# ABERT RANCH SUBDIVISION

## A Rural Residential Subdivision in the NE Quarter of Section 23 and in the NW Quarter of Section 24, Township 11 South, Range 66 West of the 6th P.M., El Paso County, Colorado.

Markup Summary

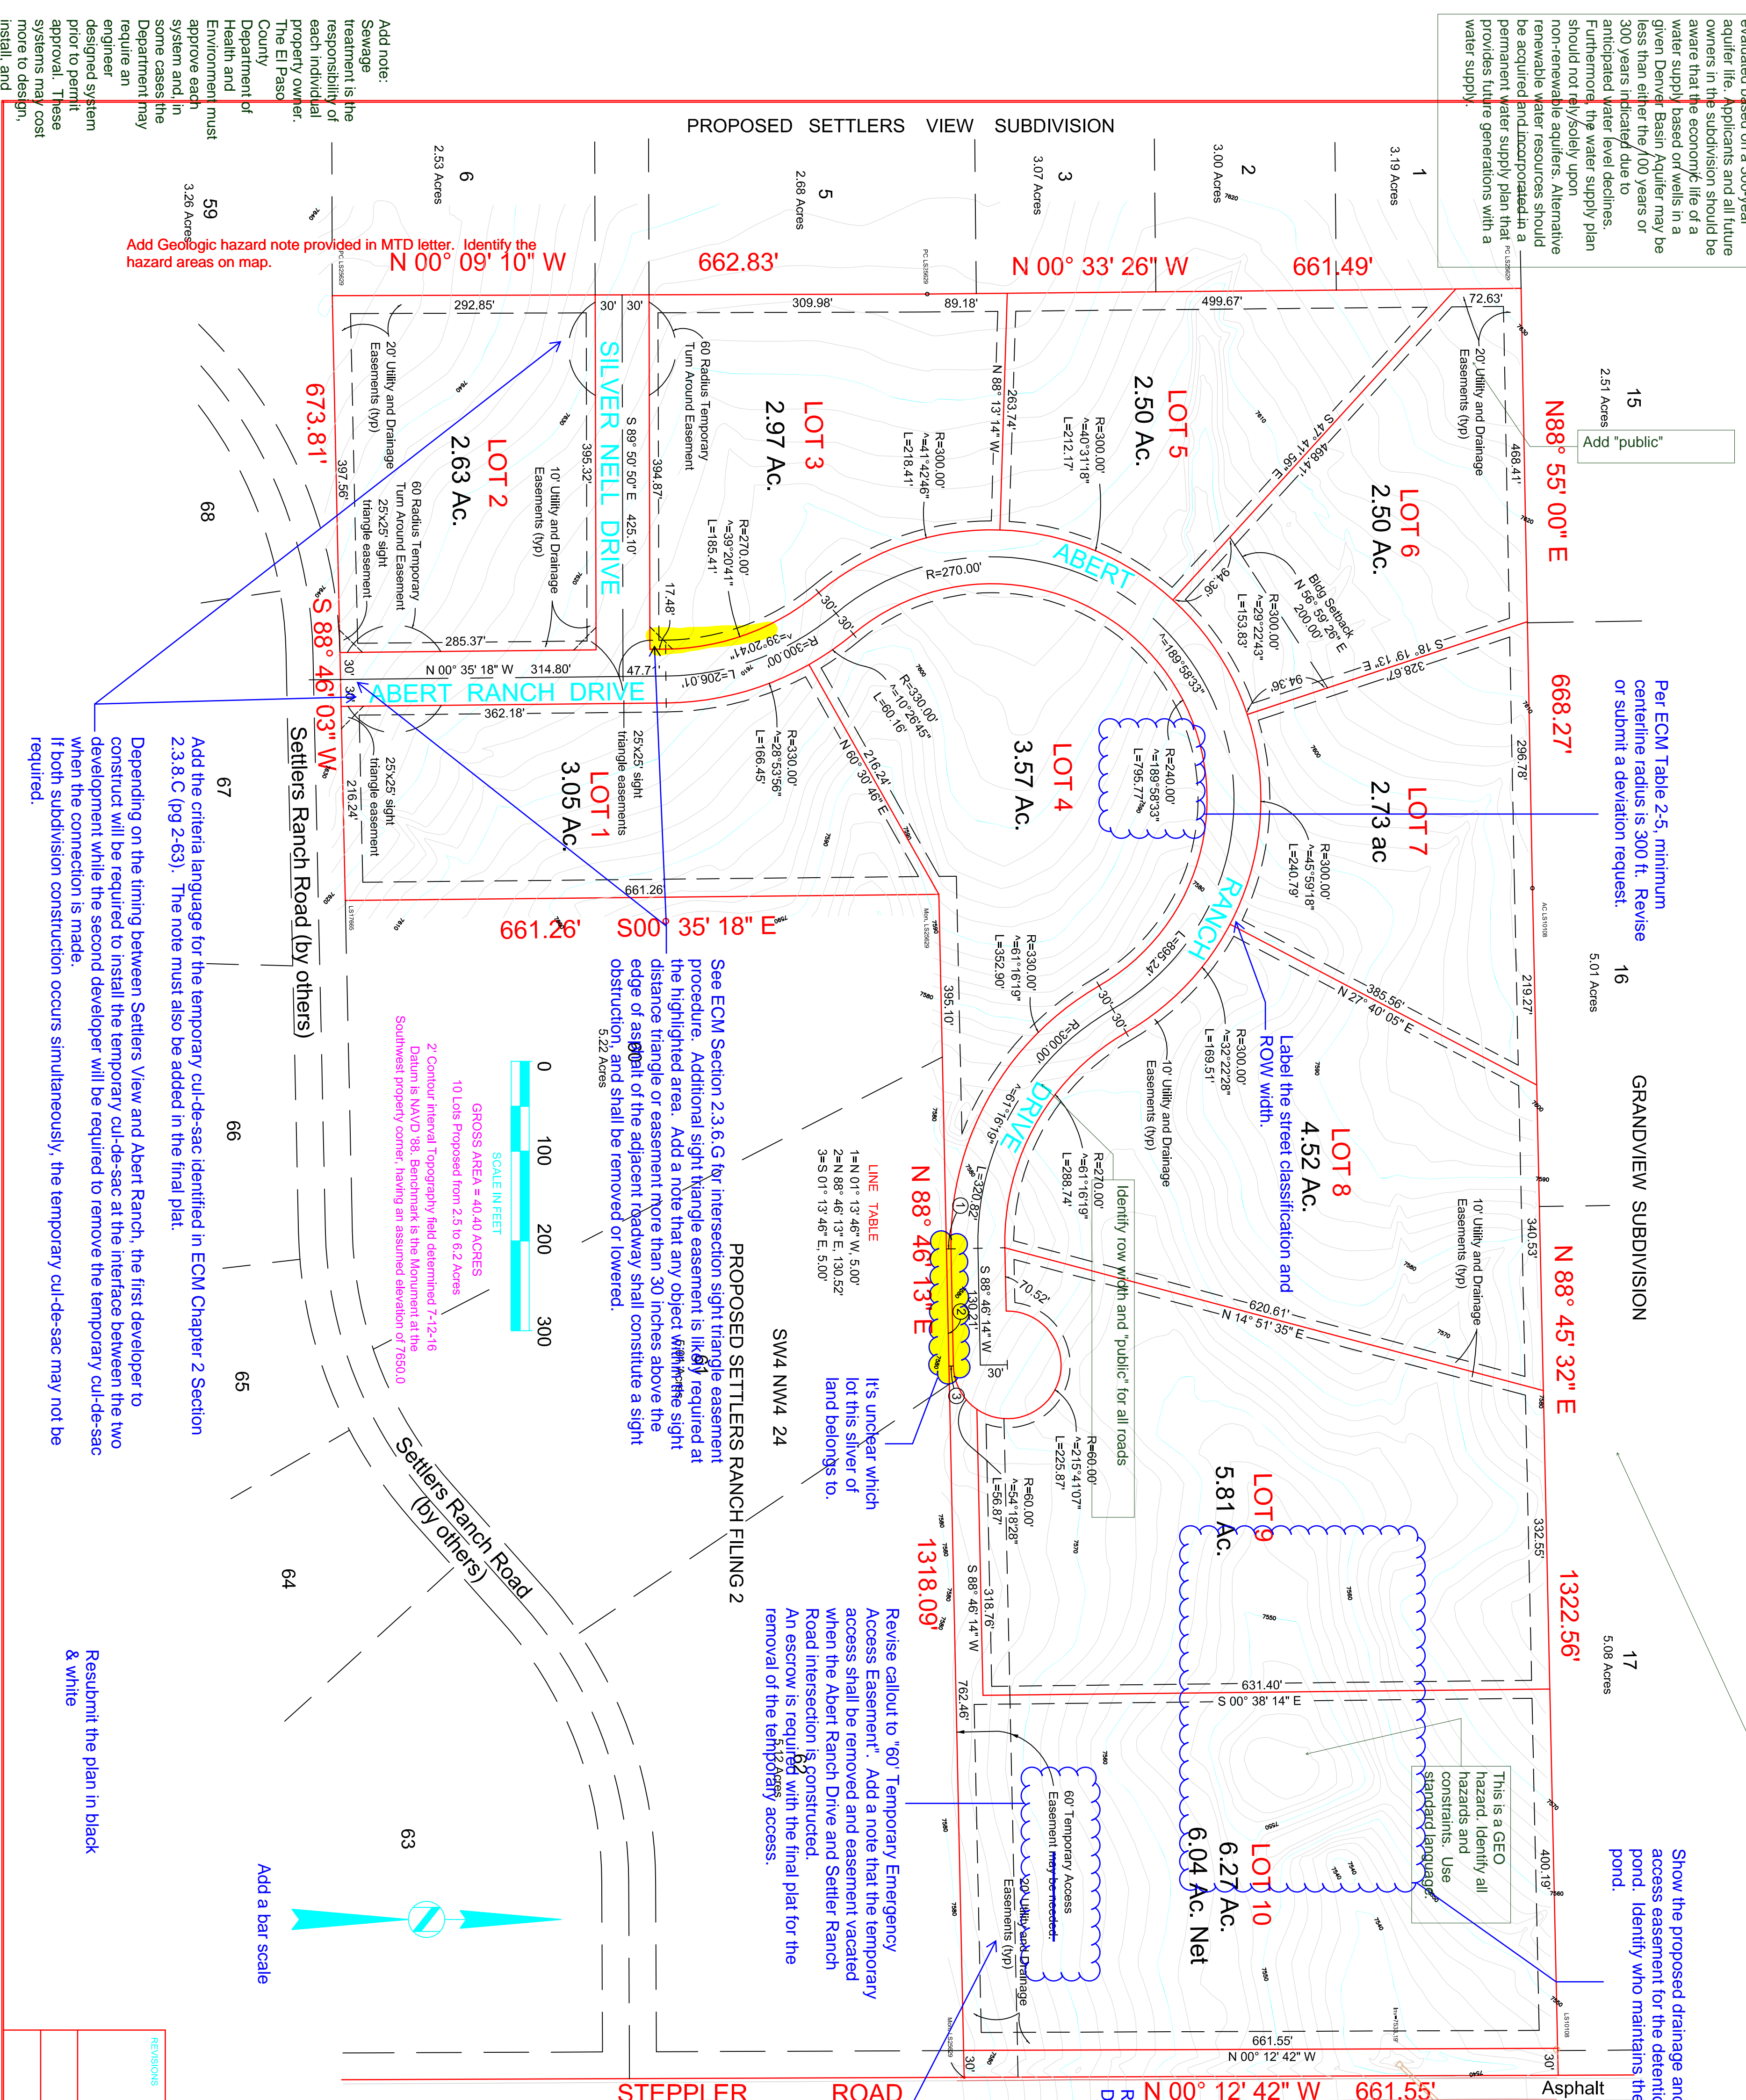
Add note: Water supply: (utilized when the water supply is individual wells). The exact wording of plot notes regarding well water supply depends upon the language of the water decree and/or augmentation plan, and will be reviewed and approved by the County Attorney's Office).

Individual wells are the responsibility of each property owner. Permits for individual wells must be obtained from the State Engineer who by law has the authority to set conditions for the issuance of these permits. Water in the Denver Basin Aquifers is allocated based on a 100-year aquifer life. However, for El Paso County planning purposes, water in the Denver Basin Aquifers is evaluated based on a 300-year aquifer life. Applicants and all future owners in the subdivision should be aware that the economic life of a water supply based on wells in a given Denver Basin Aquifer may be less than either the 100 years or 300 years indicated due to anticipated water level declines. Furthermore, the water supply plan should not rely solely upon non-renewable aquifers. Alternative renewable water resources should be acquired and incorporated in a permanent water supply plan that provides future generations with a water supply.

Per ECM Table 2-5, minimum centerline radius is 300 ft. Revise or submit a deviation request:  
 15 2.51 Acres Add "public"  
 16 5.01 Acres GRANDVIEW SUBDIVISION  
 17 5.08 Acres

Revise title to "Preliminary Plan for Abert Ranch Subdivision"

**ADD NOTE:** Sewerage treatment is the responsibility of each individual property owner. The El Paso County Department of Health and Environment must approve each system and in some cases the Department may require an engineer designed system prior to permit approval. These systems may cost more to design, install, and maintain.

**ADD NOTE:** Add the criteria language for the temporary cul-de-sac identified in ECM Chapter 2 Section 2.3.8 C (pg 2-63). The note must also be added in the final plat.

Depending on the timing between Settlers View and Abert Ranch, the first developer to construct will be required to install the temporary cul-de-sac at the interface between the two development while the second developer will be required to remove the temporary cul-de-sac when the connection is made. If both subdivision construction occurs simultaneously, the temporary cul-de-sac may not be required.

Resubmit the plan in black & white

**PROPOSED SETTLERS RANCH FILING 2**  
 It is unclear which lot this sliver of land belongs to.

**Who are the utility providers to be? Add notes.**

**ADD NOTE:** Add a typical roadway cross section detail for the Temporary Emergency Access road.

**ADD NOTE:** Show the proposed drainage and access easement for the detention pond. Identify who maintains the pond.

**ADD NOTE:** This is a GEO hazard. Identify all hazards and use standard language to flag the hazard.

**ADD NOTE:** Label the street classification and ROW width.

**ADD NOTE:** Identify row width and "public" for all roads

**ADD NOTE:** Revise to Preliminary Drainage Report.

**ADD NOTE:** Revise callout to "60' Temporary Emergency Access Easement". Add a note that the temporary access shall be removed and easement vacated when the Abert Ranch Drive and Settler Ranch Road intersection is constructed. An escrow is required with the final plat for the removal of the temporary access.

**ADD NOTE:** Note on the plan that Lot 1 and 2 shall not have direct lot access from Settlers Ranch Road and Lot 10 shall not have direct lot access from Steppler Road.

**ADD NOTE:** Add a bar scale

See ECM Section 2.3.6.G for intersection sight triangle easement procedure. Additional sight triangle easement is likely required at the highlighted area. Add a note that any object within the sight distance triangle or easement more than 30 inches above the edge of asphalt of the adjacent roadway shall constitute a sight obstruction, and shall be removed or lowered.

Per ECM Table 2-5, minimum centerline radius is 300 ft. Revise or submit a deviation request.

Add the criteria language for the temporary cul-de-sac identified in ECM Chapter 2 Section 2.3.8.C (pg 2-63). The note must also be added in the final plat.

Add a typical roadway cross section detail. Per the EPC standard detail for Rural Local Roadway, a 5' public improvement along the ROW shall be granted to El Paso County.

Delete proposed. The rezone will be approved prior to the prelim.

Add Geologic hazard note provided in MTD letter.  
Identify the hazard areas on map.

Identify the adjacent zoning and land uses for all boundaries. The east boundary will have existing and proposed.
